MUNICIPAL PLANNING BOARD

CUP2008-00012
MPL2008-00016

Conditional Use Permit approval to permit a building over 35 ft. in height in the MU-1/T zoning district, and Master Plan approval to allow construction of a mixed-use project consisting of 3,762 sq. ft. of office and retail space and one residential unit. An intensity bonus is also being requested.

AGENDA ITEM 3 ■ DOWD BUILDING

GROUND FLOOR PLAN

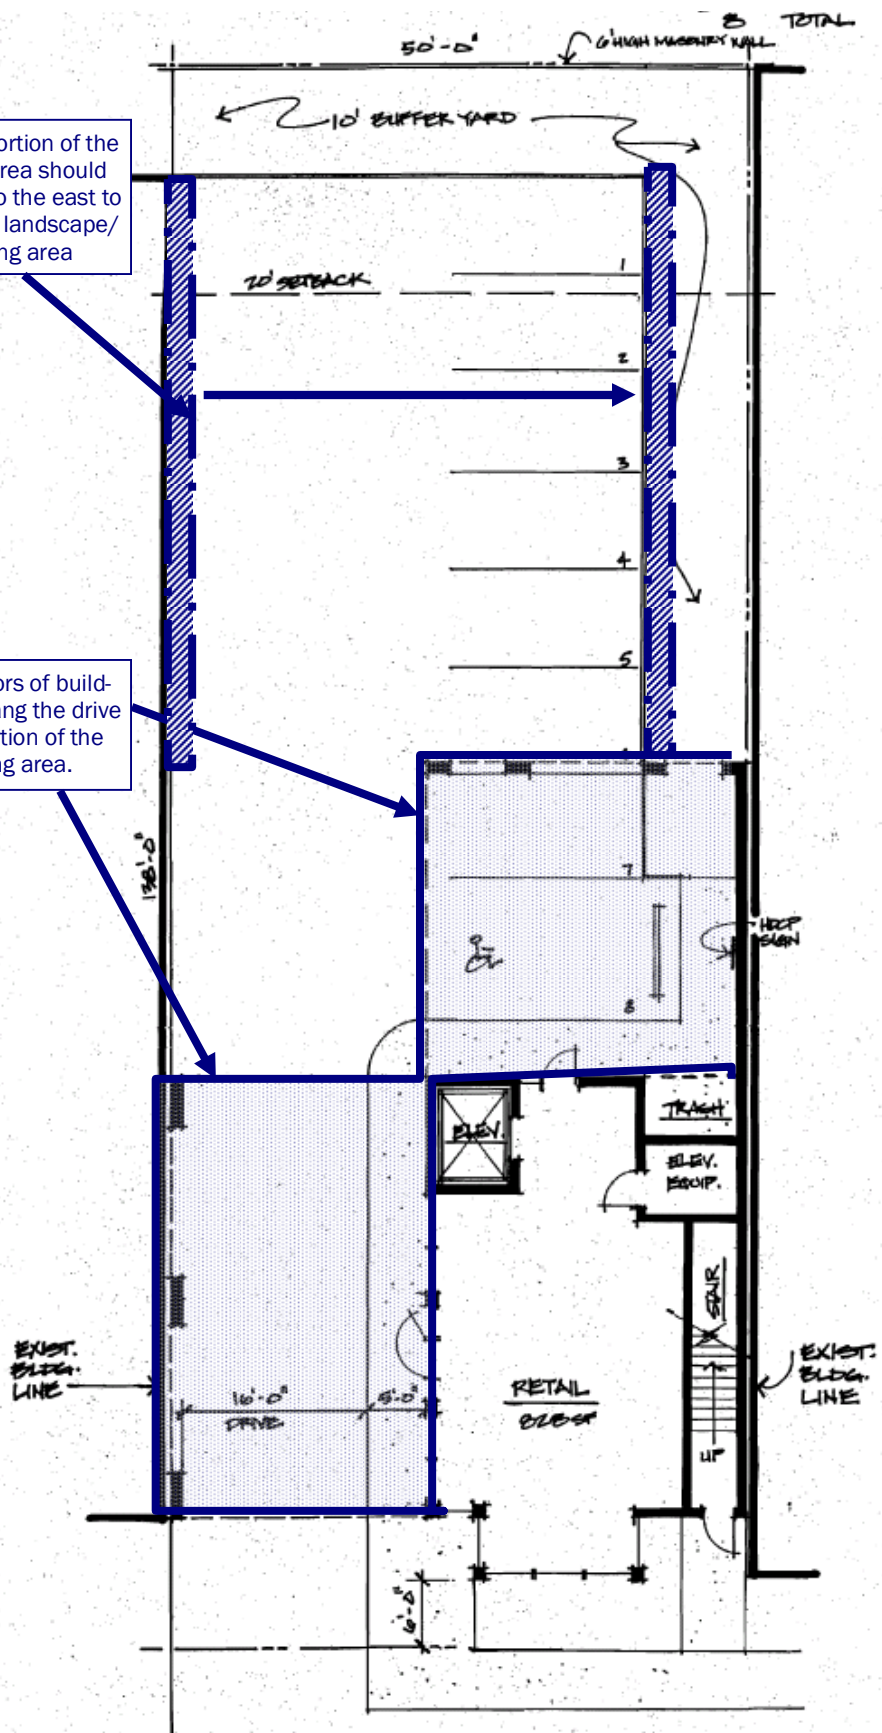
Western portion of the parking area should shift 3 ft. to the east to allow for a landscape/planting area

Upper floors of building overhang the drive aisle/portion of the parking area.

18. **Parking Lot Landscaping.** The western edge of the parking lot, where the building overhang ends, shall be shifted 3 ft. to the east to create a landscape area. A minimum of 6 palm trees shall be planted in this landscape strip, plus living screening materials or shrubs (Florida Anise or Walters Viburnum are recommended). Canopy trees shall be planted along the eastern edge, or where necessary required tree points for the eastern edge may be permitted to be planted in the northern landscape area. The final plan shall be submitted for review and approval by the City's Appearance Review Officer.
